United States Patent and Trademark Office

APPLICATION NO. FILING DATE FIRST NAMED INVENTOR ATTORNEY DOCKET NO. CONFIRMATION NO. 02/27/2004 10/789,929 Eric S. Cole 079361-9034-01 6802 **EXAMINER** 23409 7590 08/31/2005 MICHAEL BEST & FRIEDRICH, LLP EDGAR, RICHARD A 100 E WISCONSIN AVENUE ART UNIT PAPER NUMBER MILWAUKEE, WI 53202

DETAILED ACTION

FIG. 1

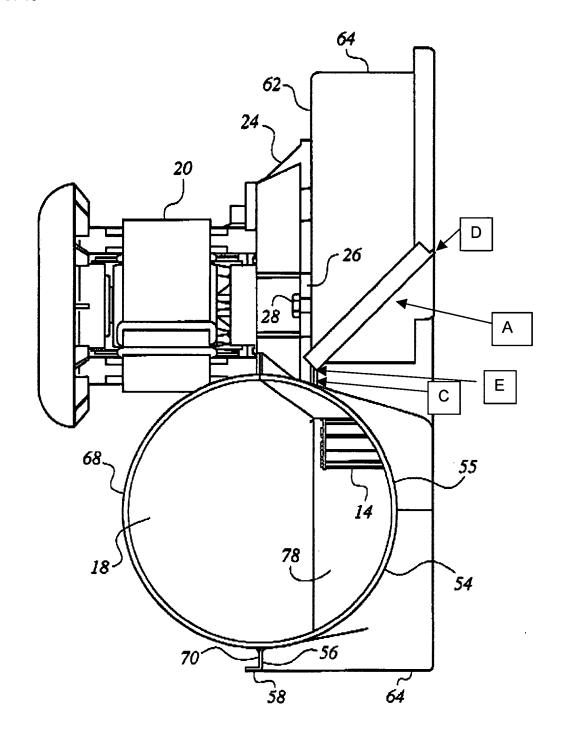
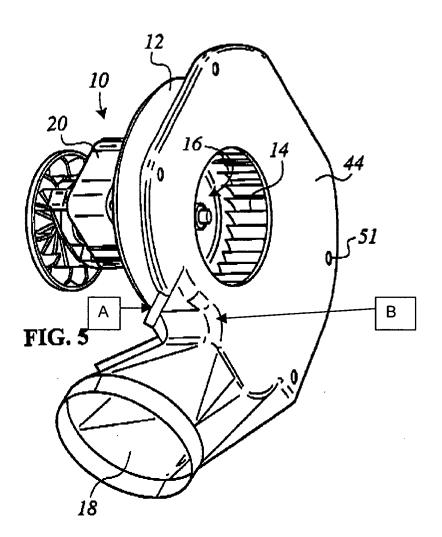
Garrison et al. teach a fan housing for a fan rotatable about an axis, the fan housing comprising: a first housing component 40 at least partially defining an internal chamber 32 adapted to receive the fan 14; and an inlet wall 44 having an inlet aperture 16 through which fluid enters the fan housing; the first housing component 40 comprising a transition section 55 extending away from the inlet aperture 16 toward an exhaust outlet 18 and through which fluid passes from the internal chamber 32 to the exhaust outlet 18; an axially-extending side wall 52 located adjacent the exhaust outlet 18; a second housing component 42 complementary to the first housing component 40 and at least partially defining the internal chamber 32, the second housing component 42 comprising a transition section 54 extending toward the exhaust outlet 18 and through which fluid passes from the internal chamber 32 to the exhaust outlet; and a side wall 64 extending axially toward the first housing component 40 and shaped complementary to the axially-extending side wall 52 of the first housing component 40; and a housing seam 60 defined between the side wall 52 of the first housing component 40 and the side wall 64 of the second housing component 42, the seam having a length extending at least partially about the axis while extending axially (see annotation A).

The fan housing further comprises a cutoff (see annotation B) located adjacent the exhaust outlet 18 and defining high and low pressure areas at different circumferential positions about the axis; wherein the seam 60 runs about the axis from one side of the exhaust outlet to another side of the exhaust outlet, and the cutoff (B) is located between the exhaust outlet 18 and the length of the seam extending at least partially about the axis while extending axially (A).

The length of the seam A extends about less than a majority of the circumference of the side walls (see Fig. 1); and another length of the seam extends about another portion of the circumference of the side walls (see Fig. 6).

The side wall 52/64 is substantially volute (see Fig. 3), and extends between a location adjacent one side of the exhaust outlet to a location adjacent another side of the outlet; and the length of the first portion of the seam A is located adjacent the exhaust outlet (see Fig. 1).
